MIDWEST POOLED FUND PROGRAM

Progress Report - First Quarter 2010 January 1st to April 2nd

Pooled Fund Consulting Summary

Midwest Roadside Safety Facility
January 2010 – April 2010

Figure 1. FLDOT Soil Fill Behind PCB Detail

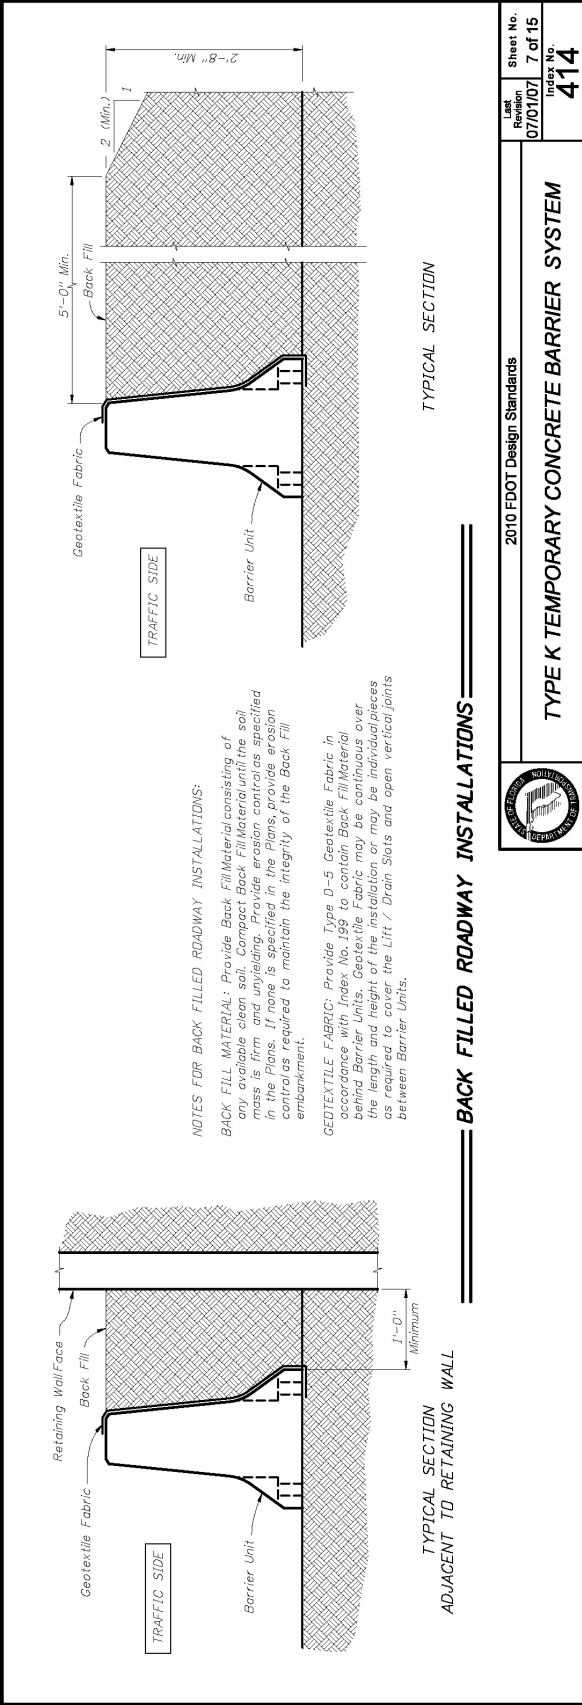
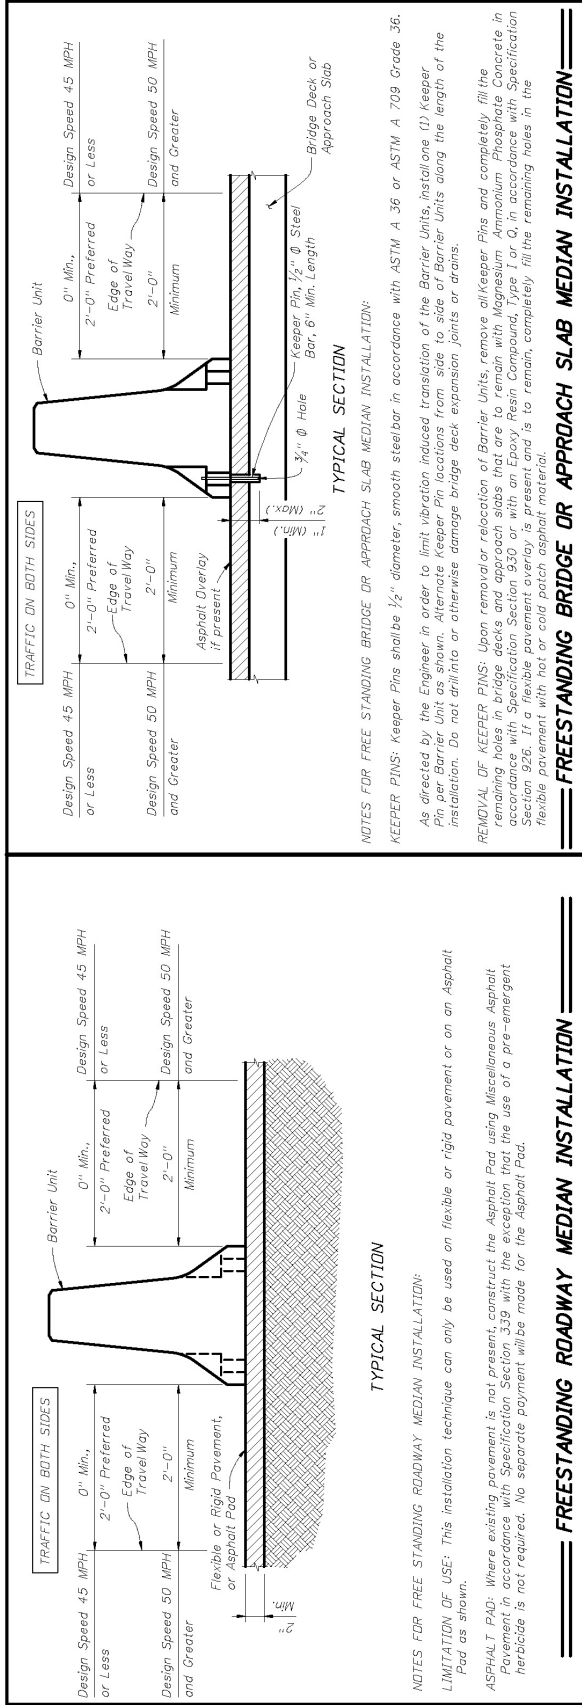
Erik Emerson with WisDOT contacted MwRSF and requested information regarding the use of soil fill behind temporary concrete barrier to reduce deflection.

Attached is the Florida DOT standards for the F-shape barrier. They have a specification in their plans for backfill behind the TCB system. We have review this for Florida in the past and gave it the seal of approval.

Figure 2. F-shape Barrier Bolt Through Tie-Down with Asphalt Overlay

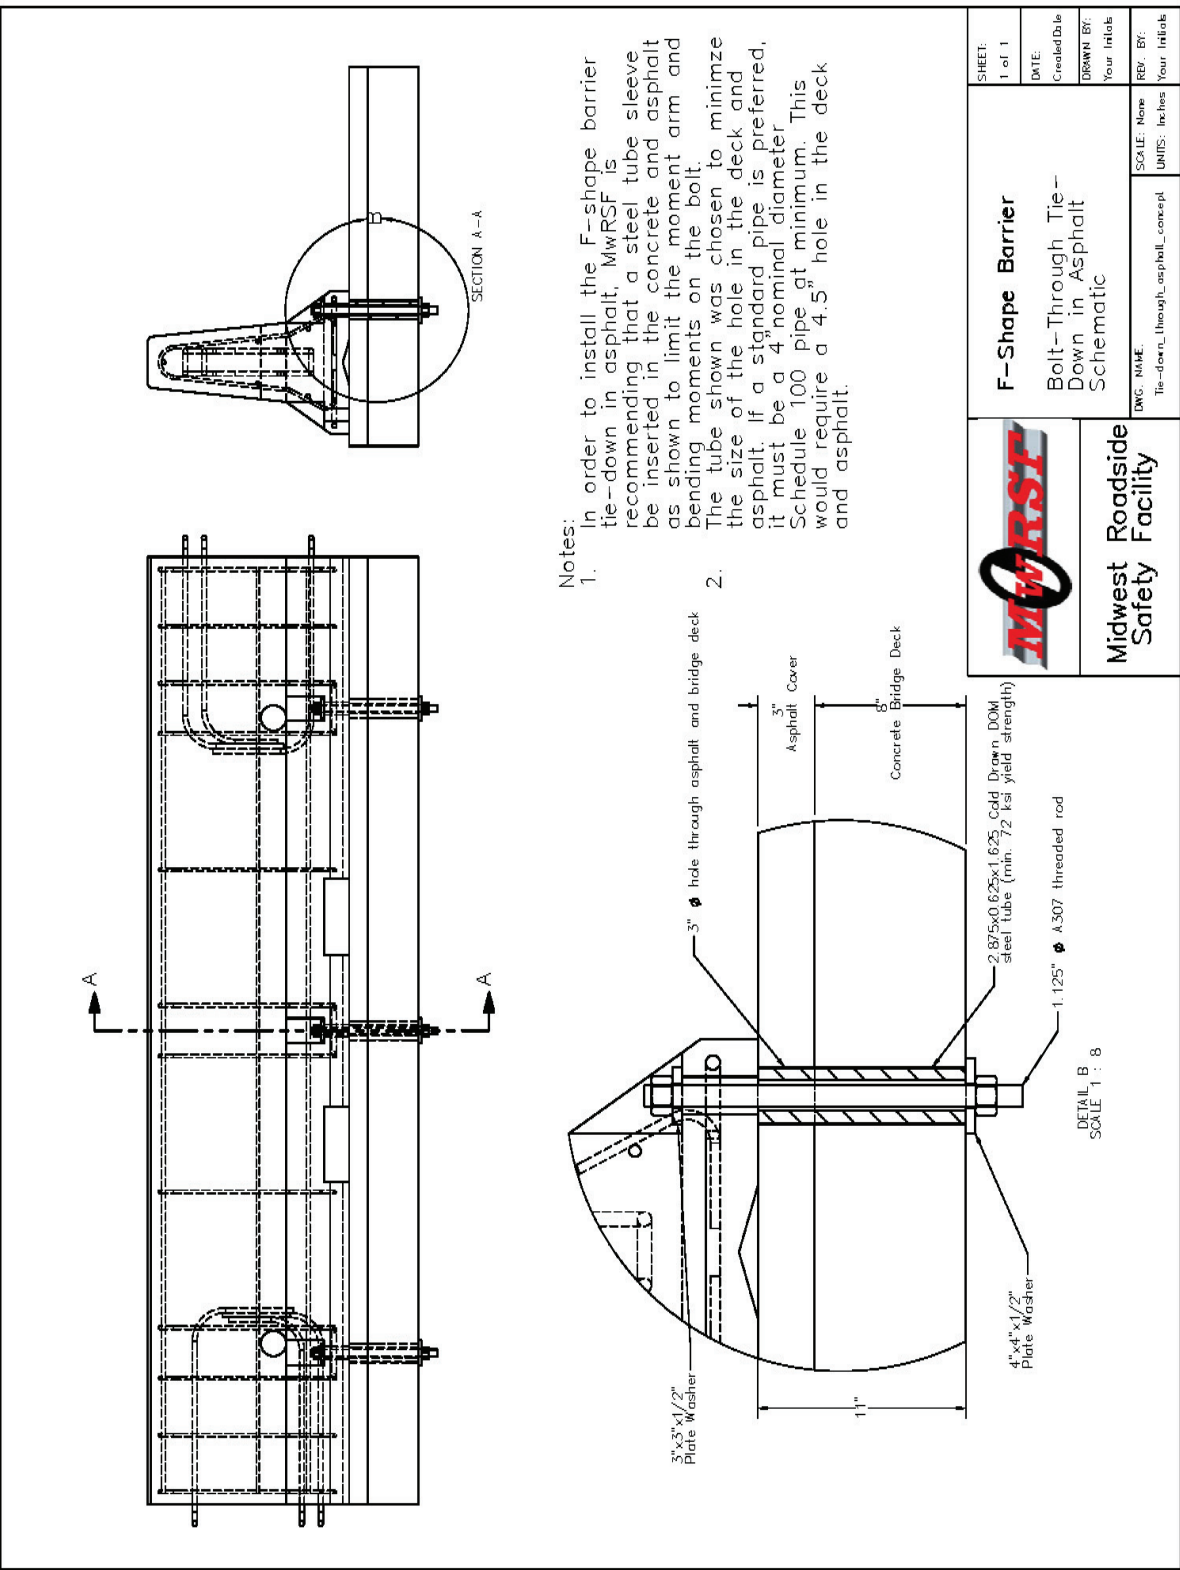
1. When performing the coring, how concerned are we going to be with capturing the slurry and the cores?
2. The detail indicates a 4" nominal diameter schedule 100 pipe can be used versus the 2.875" x 0.625 x 1.626 Cold Drawn DOM Steel Tube but it does not increase the plate washer size, does the plate washer need to be a larger diameter as well.

3. Is the threaded rod to be centered in the steel tube or off to one side? The detail appears to have the rod centered but if a 4" diameter pipe is used and the rod would have room to move around. In our case the barrier is to be mounted with one edge being directly over the saw cut. If the barrier moves as all it could be hanging over the cut edge that we are protecting. Please address.

- a. The plate washer would be larger for the 4" schedule 100 pipe. We would recommend a 7"x7"x3/4" plate washer for the larger pipe.
3. Is the threaded rod to be centered in the steel tube or off to one side? The detail appears to have the rod centered but if a 4" diameter pipe is used and the rod would have room to move around. In our case the barrier is to be mounted with one edge being directly over the saw cut. If the barrier moves as all it could be hanging over the cut edge that we are protecting. Please address.

- a. We intend the rod to be centered in the hole as much as possible. You are correct that with the larger pipe size you can expect a shift of the barrier due to the extra room. This distance would be a maximum of 2". Thus, we would recommend that you allow for 2" of additional room on the back of the barrier adjacent to the saw cut to account for the additional translation. I also want to note that you should not be installing this system with the back of the barrier flush with the saw cut. The design was developed and tested for use with a minimum of a 1" gap between the backside of the barrier and the edge of the concrete. As such, we would recommend that you keep the 1" gap for all installations and increase the gap to 3" when using the larger pipe.

Figure 4. Revised Cable Anchor Bracket CAD

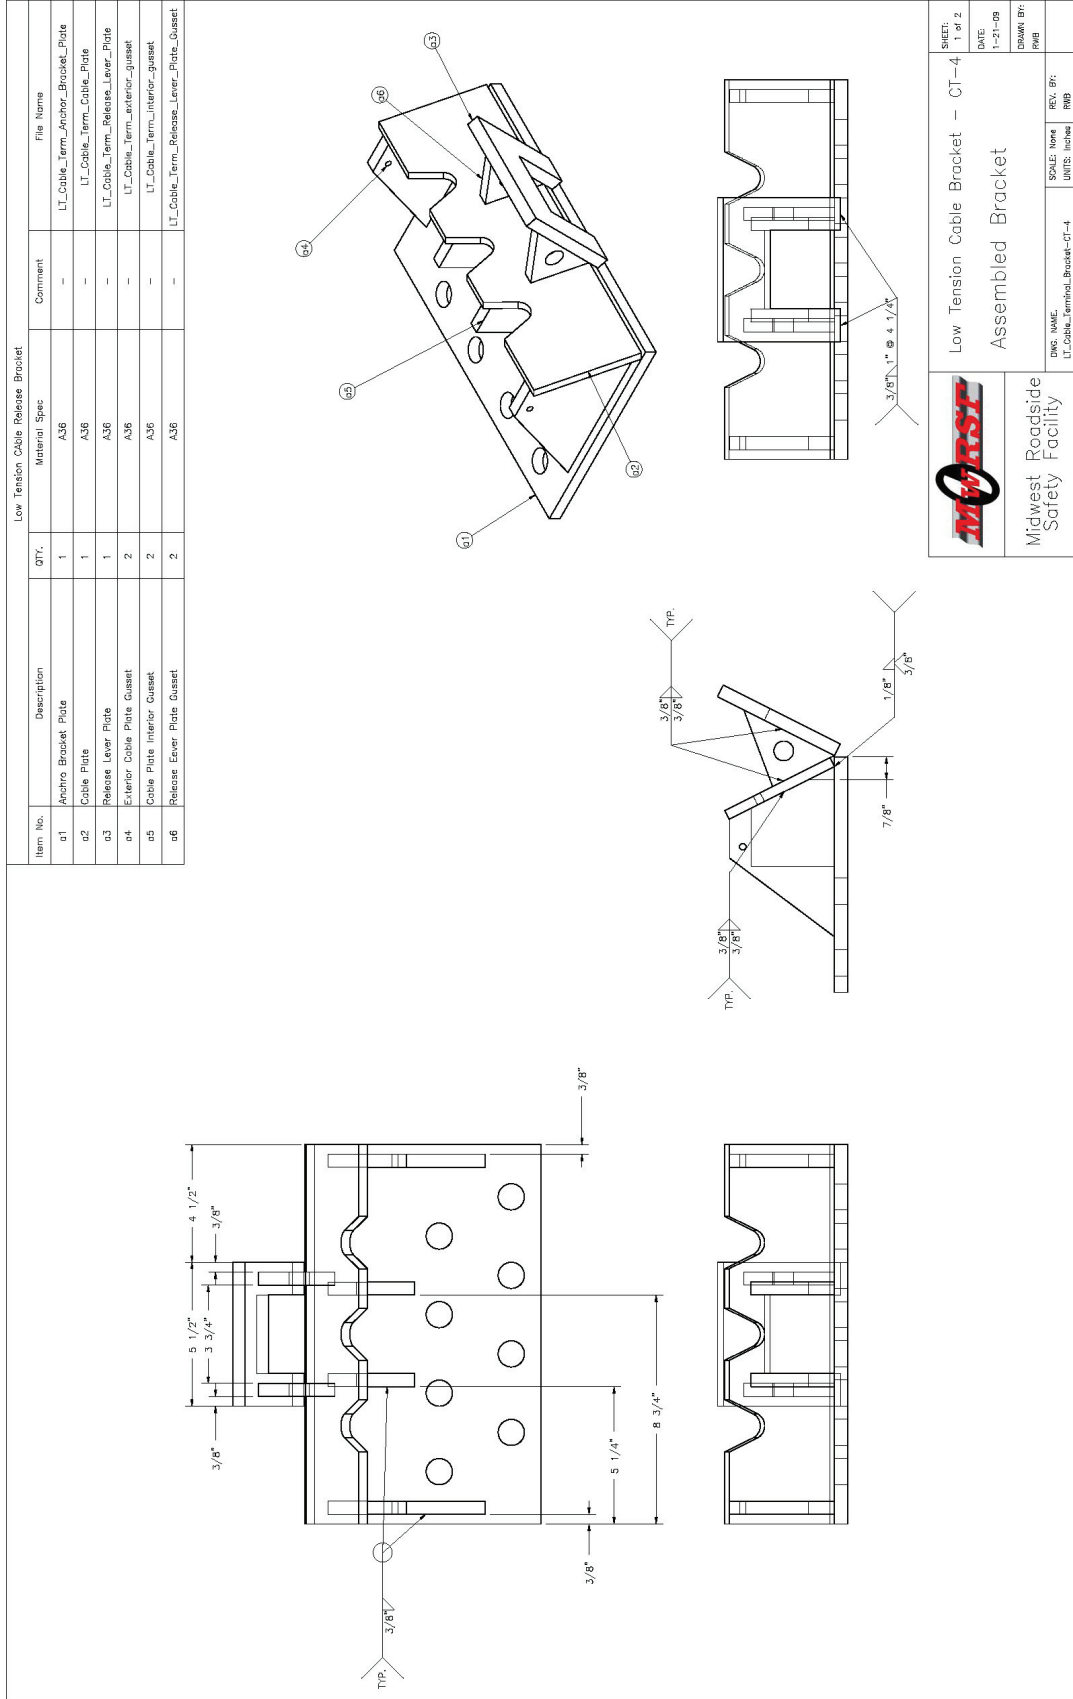
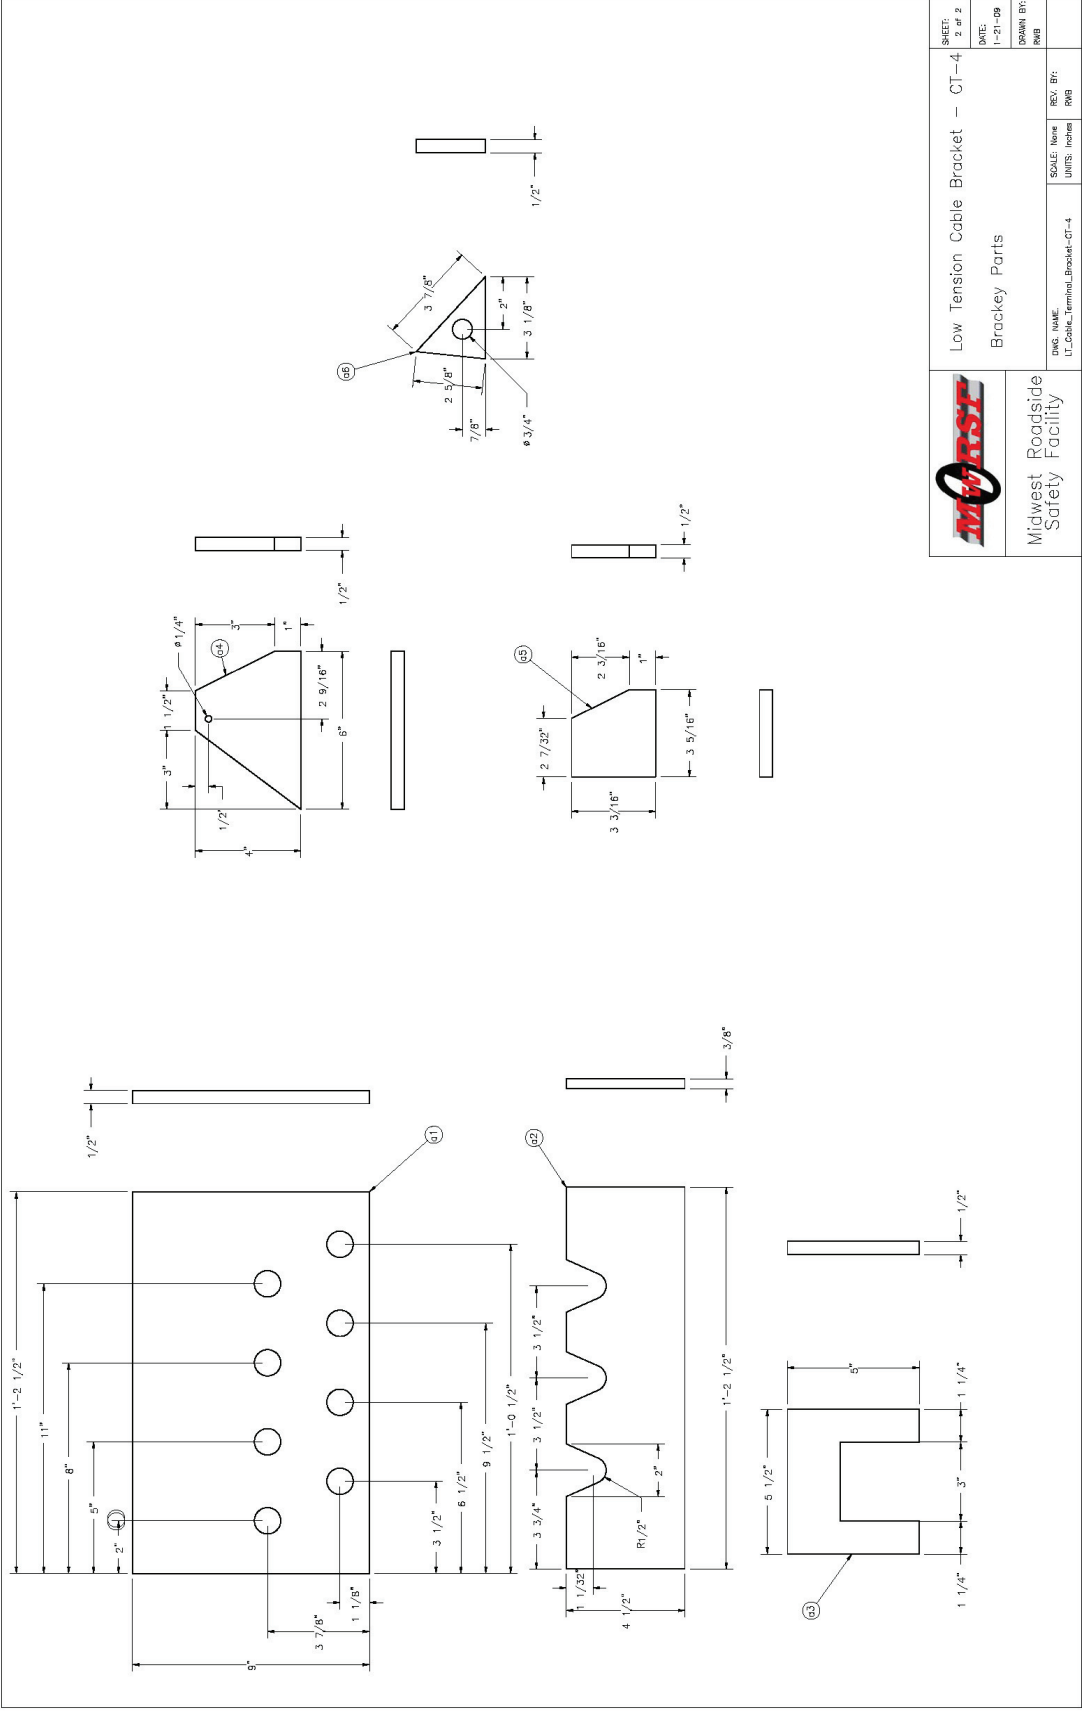
We found a bolt in these holes of report TRP-03-192-08 Figure A-2 Cable Terminal Detail, sheet 2 of 12.

- This is another error in our CAD. The weld callout should read “ 1” @ 4 1/4” C-C”. This will center the weld correctly on the release lever plate.
- I have reviewed the original CAD for the bracket welds and you CAD which appears to be based on it. The weld labeling is confusing and not entirely consistent with what was built. As such, I have drawn a revised detail that should help clear the confusion. Note that some of the dimensions have changed as well. I put in the space for the 3/8” welds that was lacking as well.
